Memorandum

То:	Suzannah Bigolin, Cambridge CDD	Date:	September 11, 2017
From:	Lawrence Cheng	Project:	47 Bishop Allen Drive, Cambridge
Re:	Cambridge Planning Board Design Review

Attached please find revised elevation drawings that captured the comments from the Planning Board during the meeting on September 5, 2017. There are four main suggested changes:

EAST FACADE ELEVATION

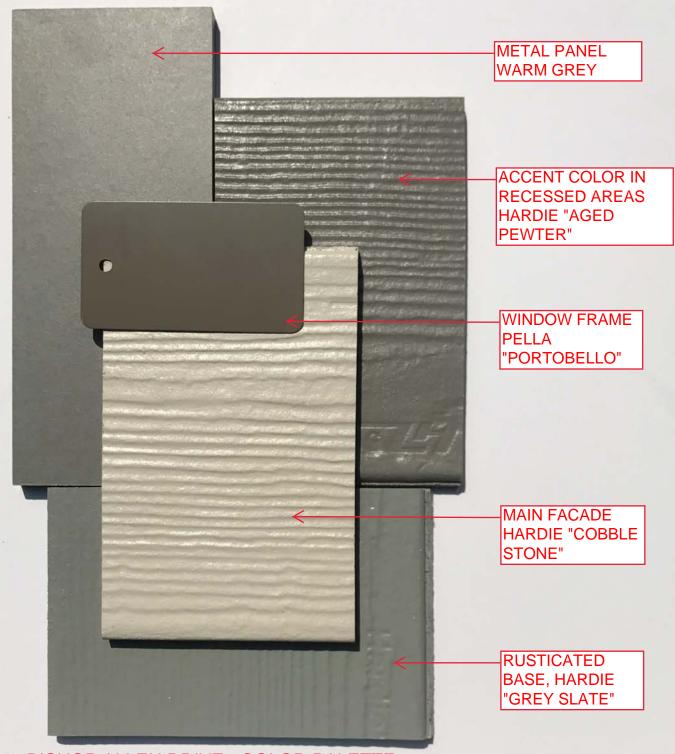
-No entry doors to units and patios facing Bishop Allen Drive. A green buffer provided to enhance privacy and better define public/private edge.

-First floor slab raised slightly to further provide privacy to units facing the street and meet DPW 2030 flood elevation requirement at 19.50 CCB.

-Combined two narrow windows units into one larger unit but w/custom thicker center mullion for ease of construction and detailing given Energy Star's requirement of continuous rigid insulation.

-Substitute better performance clad wood window for vinyl window.

-Entry vestibule and doors adjusted to work with entry sloped surface and updated program at ground floor
